06-324r8 SAS-2 Modifications to the SAS Speed Negotiation

To: T10 Technical Committee  
From: Amr Wassal, PMC-Sierra (amr\_wassal@pmc-sierra.com)  
Stephen Finch, STMicroelectronics (steve.finch@st.com)  
Date: 20 September 2006  
Subject: 06-324r7 SAS-2 Modifications to the SAS Speed Negotiation

**Figure 124 — SAS Train-SNW**

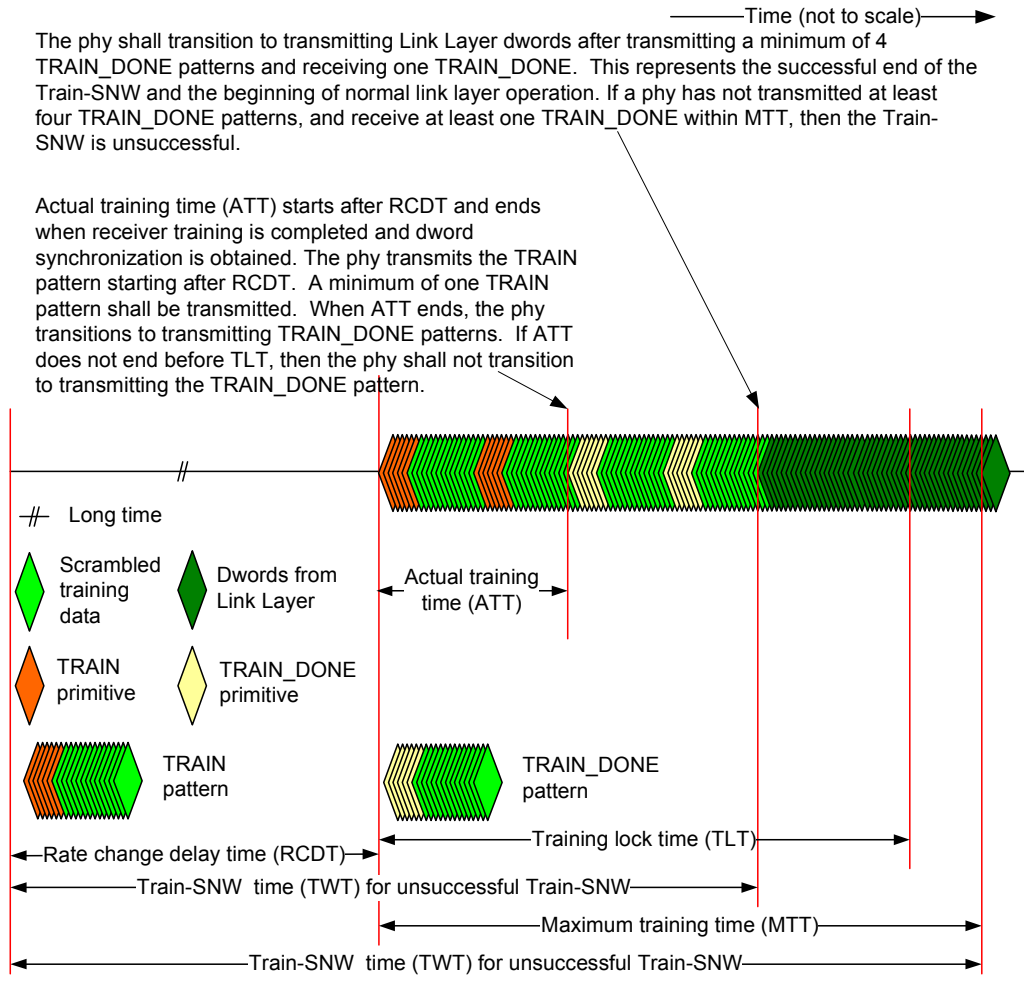
**Figure 124 updated in Rev 7.**

The phy shall transition to transmitting Link Layer dwords after transmitting a minimum of 4 TRAIN\_DONE patterns and receiving one TRAIN\_DONE. This represents the successful end of the Train-SNW and the beginning of normal link layer operation. If a phy has not transmitted at least four TRAIN\_DONE patterns, and receive at least one TRAIN\_DONE within MTT, then the Train-SNW is unsuccessful.

Actual training time (ATT) starts after RCDT and ends when receiver training is completed and dword synchronization is obtained. The phy transmits the TRAIN pattern starting after RCDT. A minimum of one TRAIN pattern shall be transmitted. When ATT ends, the phy transitions to transmitting TRAIN\_DONE patterns. If ATT does not end before TLT, then the phy shall not transition to transmitting the TRAIN\_DONE pattern.

Figure 125 — SAS speed negotiation sequence (phy A: G1, G2, G3, phy B: G2 only)

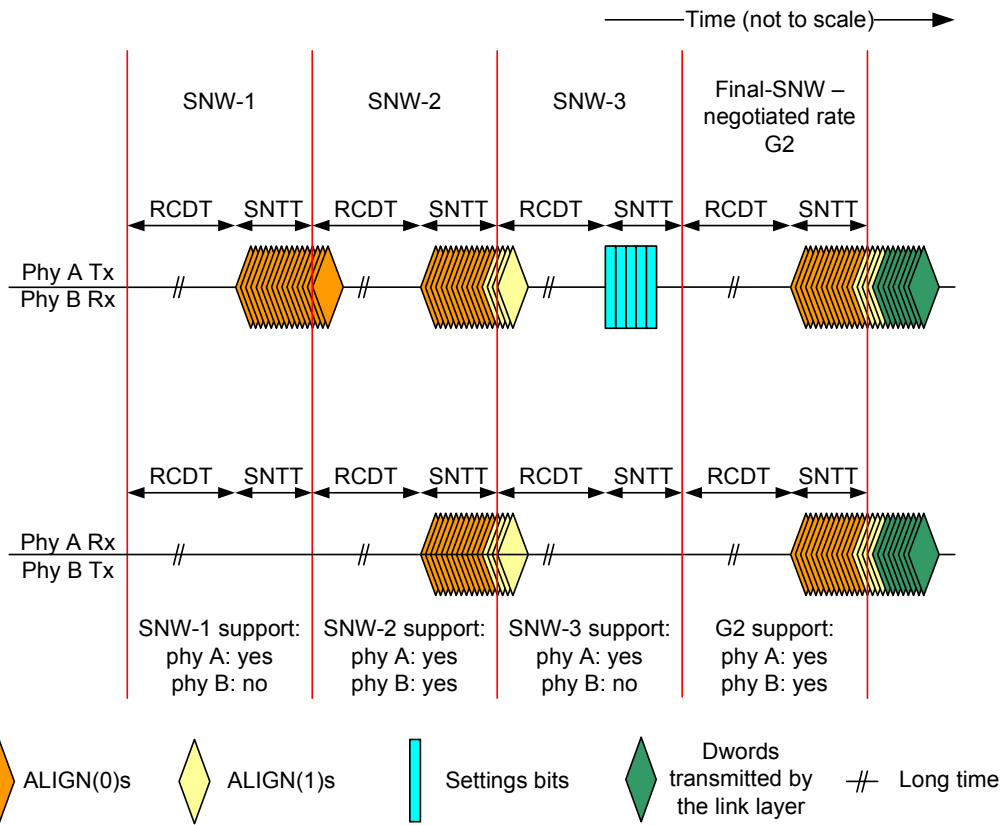
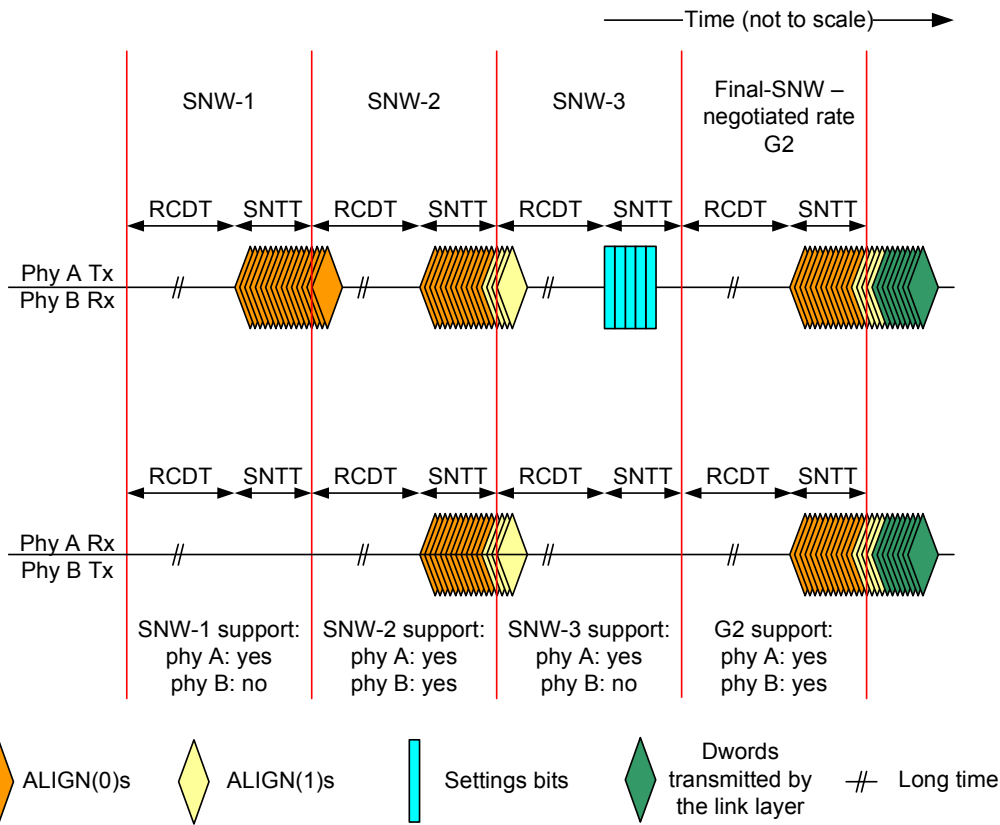
Figure 125 is an example of speed negotiation between a phy A that supports G1 through G3 and a phy B that only supports G2. Both phys participate in:

Figure 125 updated in Rev 7.

Figure 126 — SAS Final-SNW phy reset problem

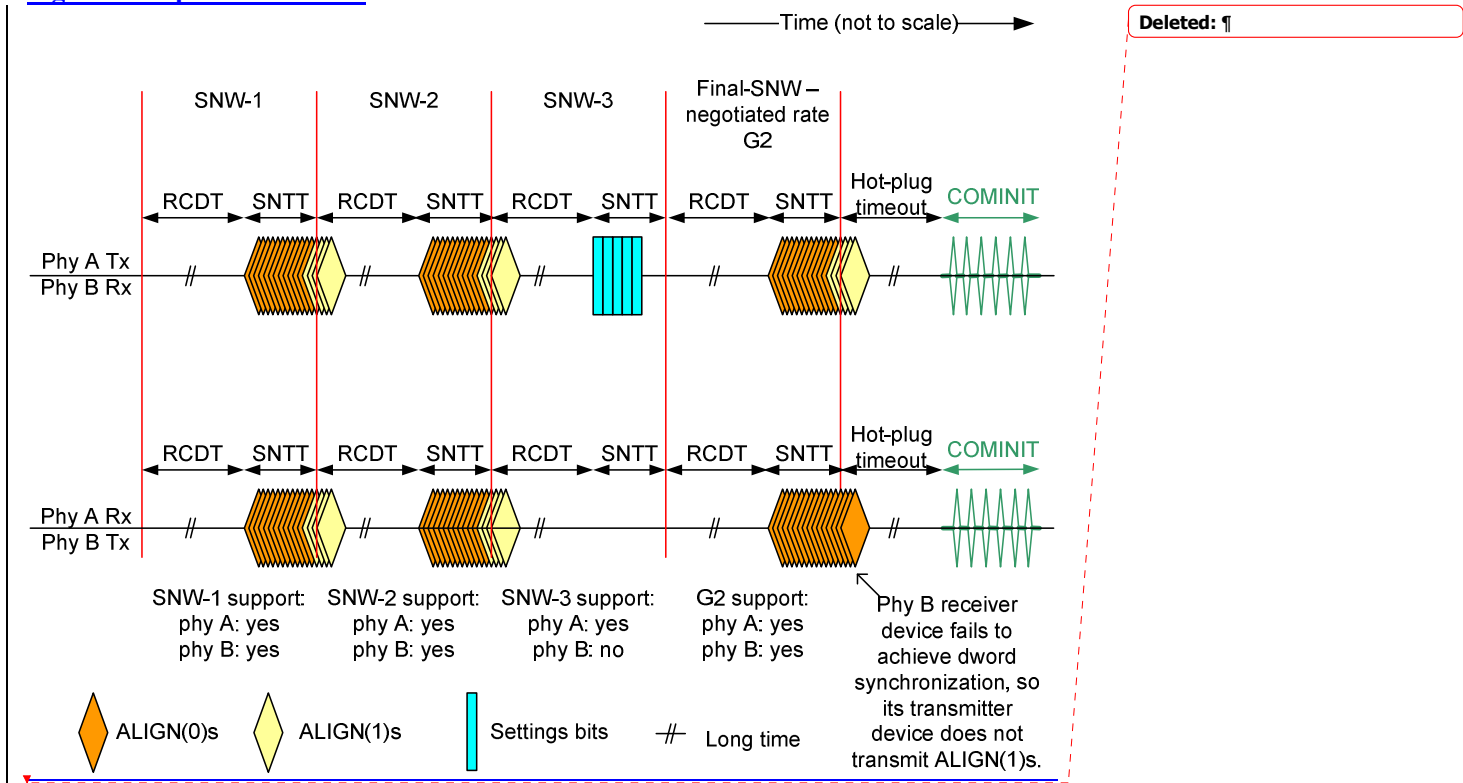
Figure 126 shows a speed negotiation sequence where phy B does not achieve dword synchronization during the Final-SNW. If this occurs, the handshake is not complete and the phy reset sequence is retried.

Figure 126 updated in Rev 7.

Figure 127 — SAS speed negotiation sequence (phy A: G1, G2, G3 or higher, phy B: G1, G2, G3 or higher)

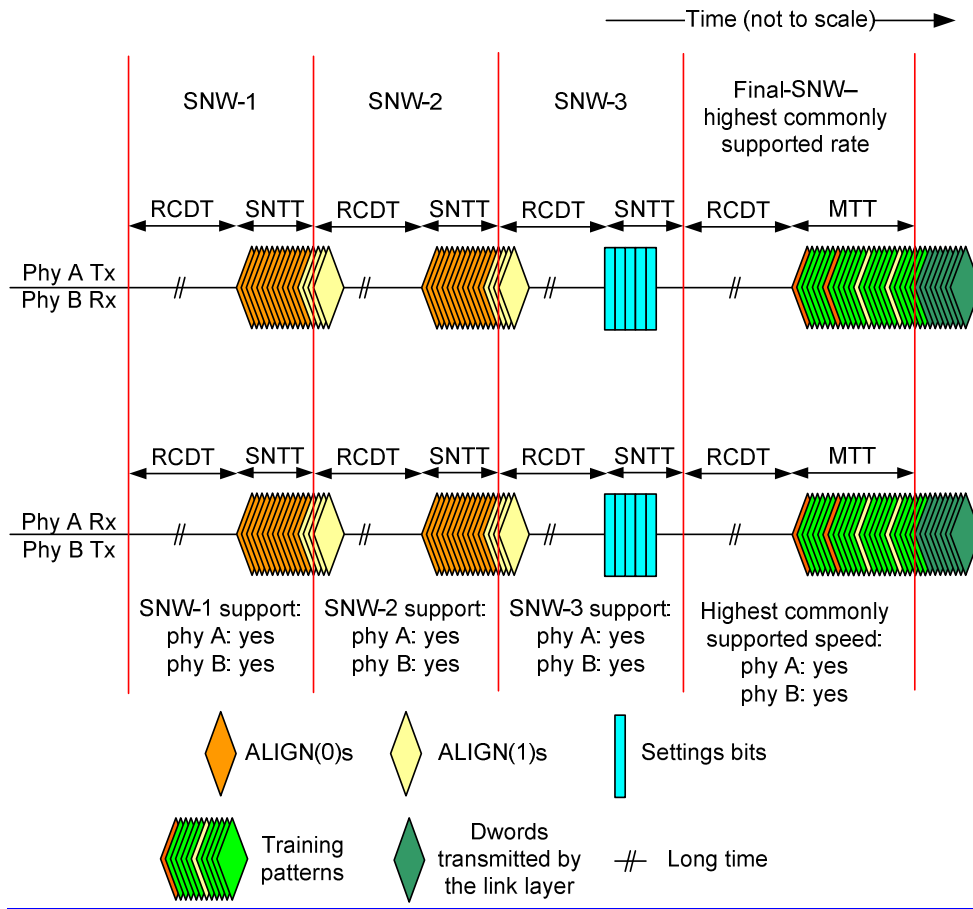
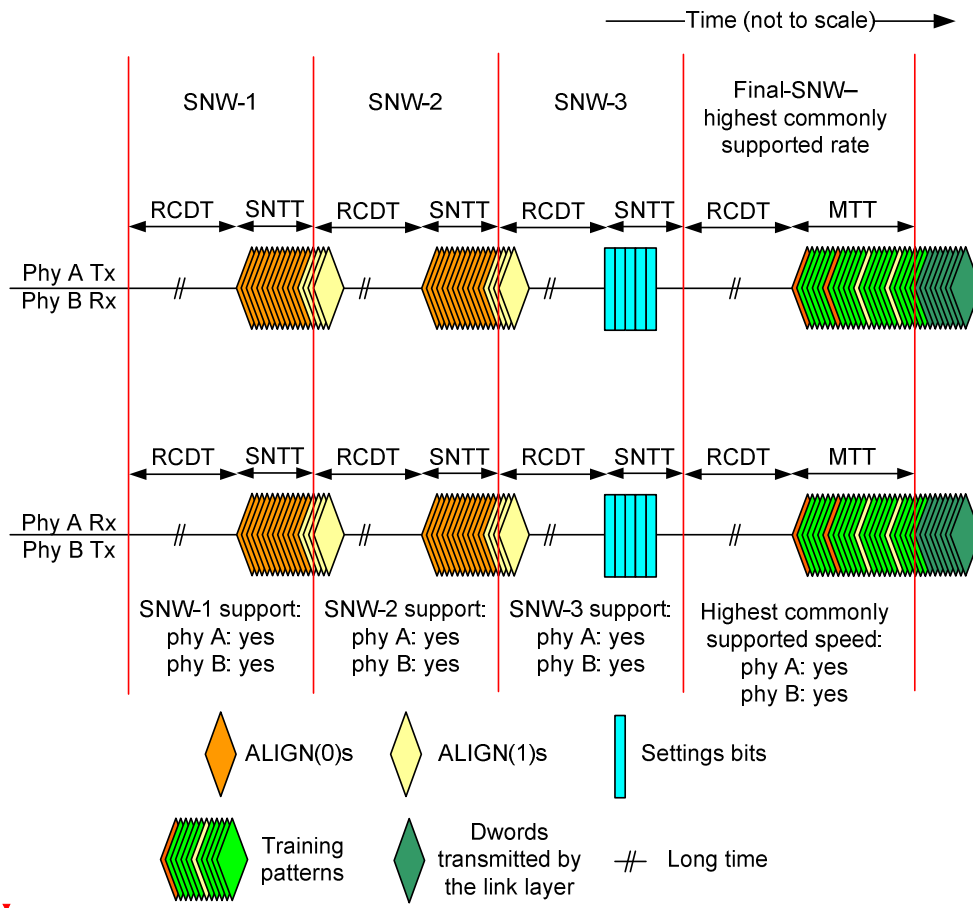
Figure 127 shows speed negotiation between a phy A and a phy B that both support G1 and G2 rates without requiring training and also support additional capabilities. Both phys participate in:

Figure 127 updated in Rev 7.

**Figure 128 — SAS speed negotiation sequence - SNW-3 (maximum SNW) phy reset problem**

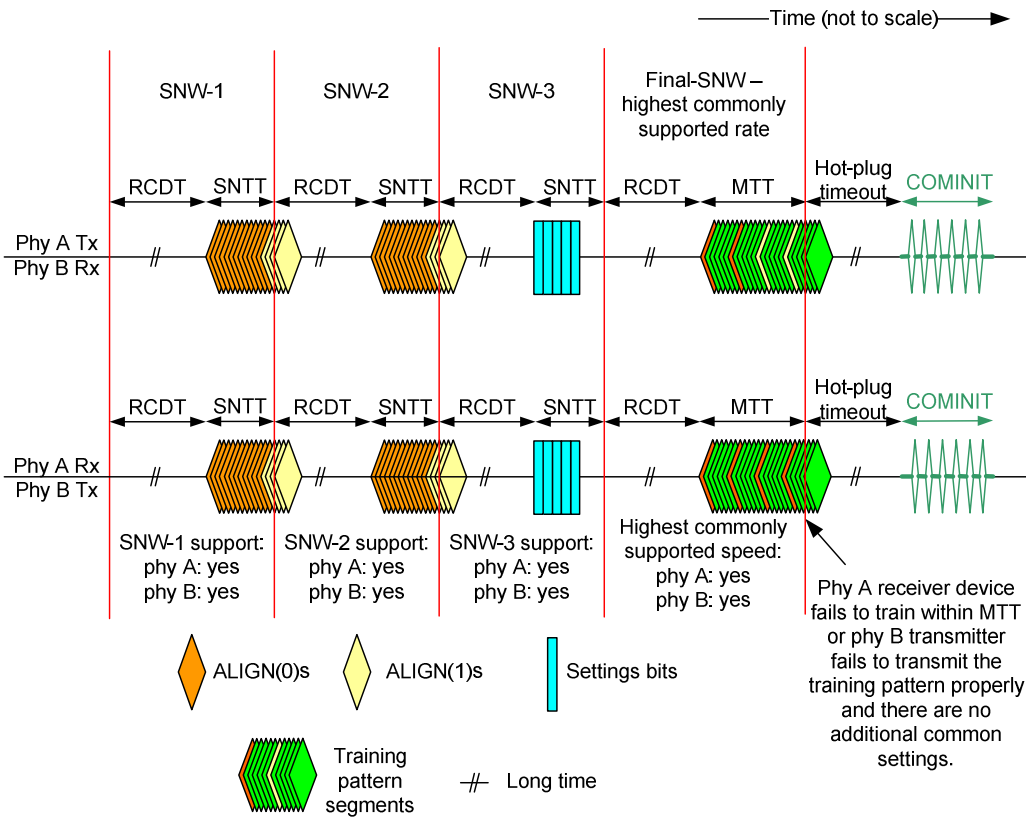
**Figure 128 updated in Rev 7.**

**Figure NEW1 — SAS speed negotiation sequence – First Train-SNW is invalid, Second Train-SNW valid**

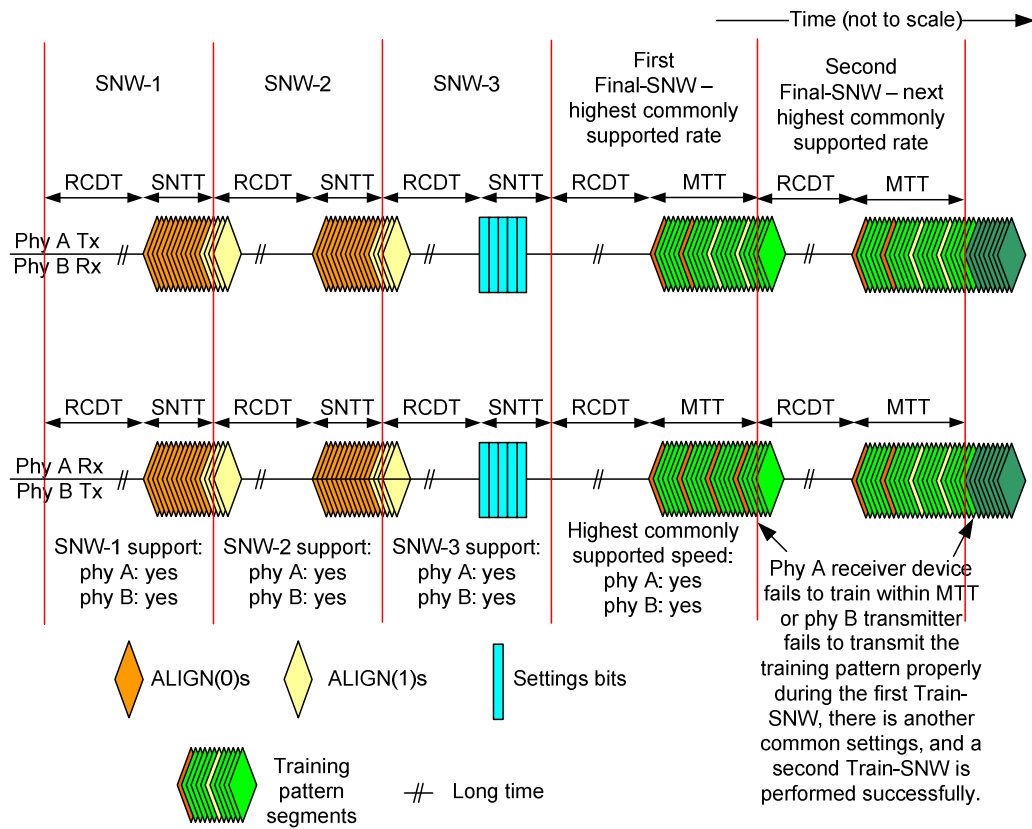
If settings bits are exchanged that contain more than one common setting and the Train-SNW using the highest common capability is invalid, a second Train-SNW is performed using the next highest common setting, as shown in Figure NEW-1.

Figure 131— SP (phy layer) state machine - SAS speed negotiation states

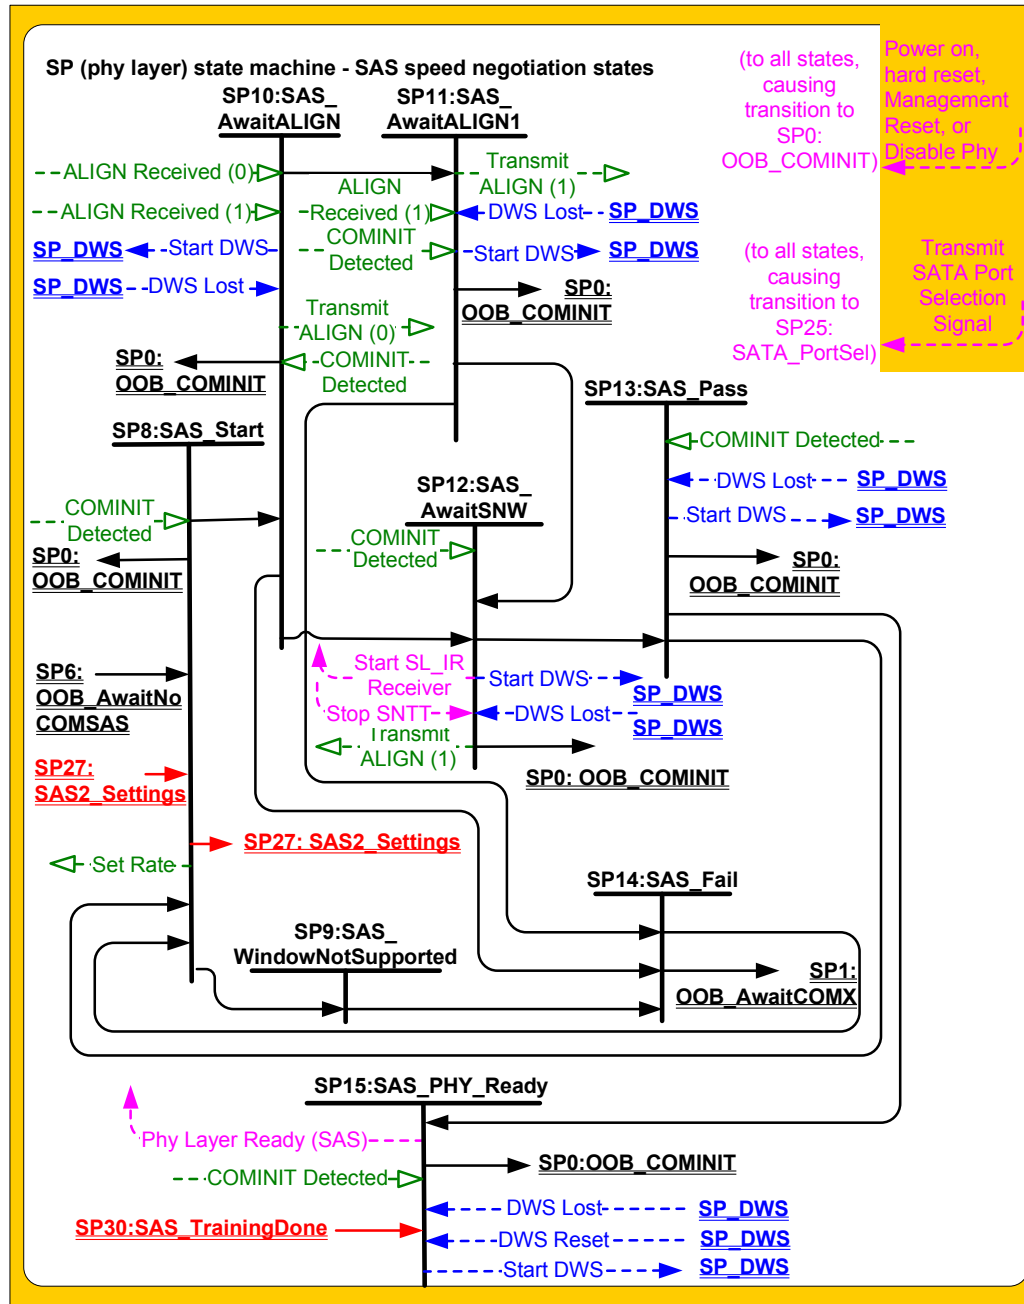
Changes to Figure 132 are in RED and Underlined in the figure. The associated transition arrows are also added in RED.

Figure 132 — SP (phy layer) state machine - SAS speed negotiation states (continued)

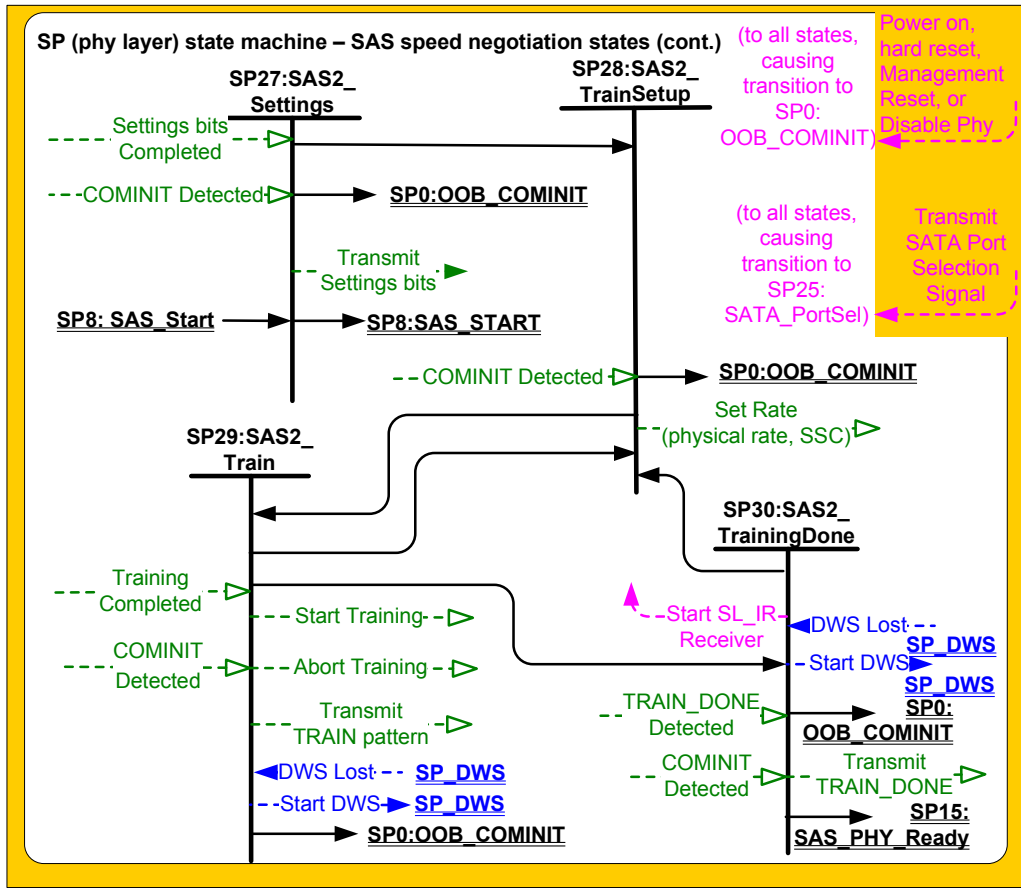
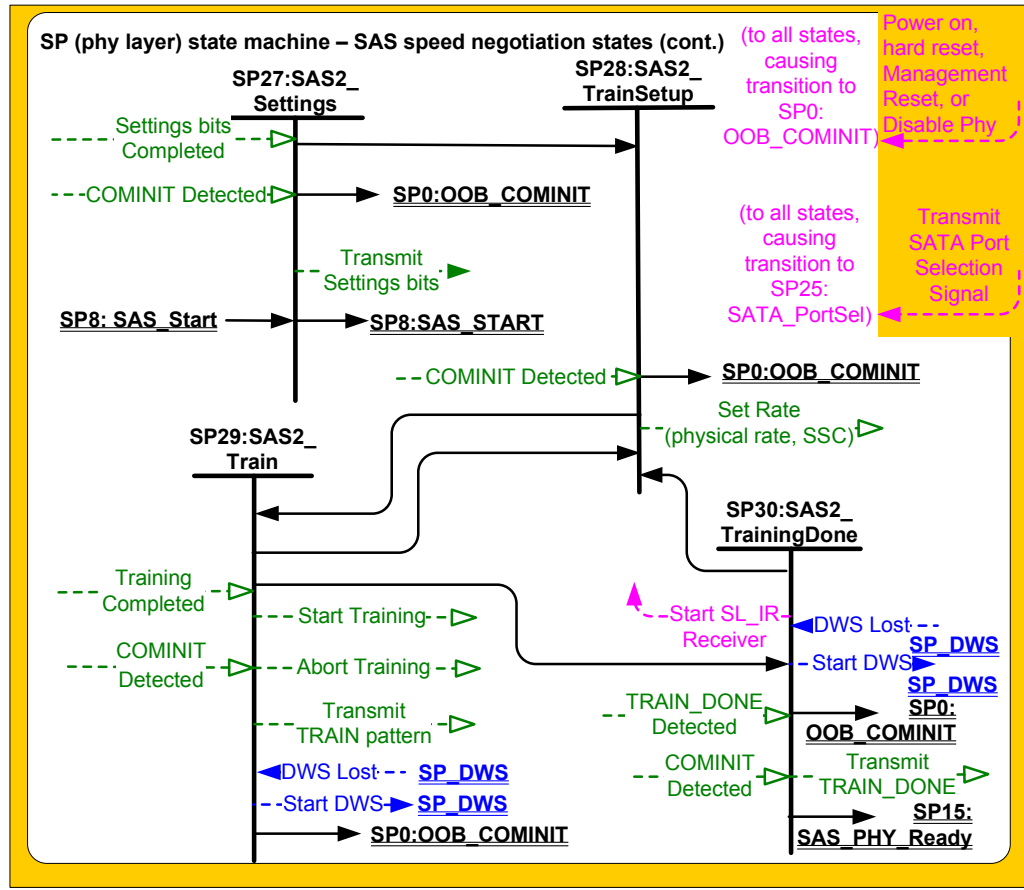
Figure 132 is a completely new figure.

Figure 132 shows the rest of the SAS speed negotiation states related to SNW-3 and the Final-SNW speed negotiation windows.
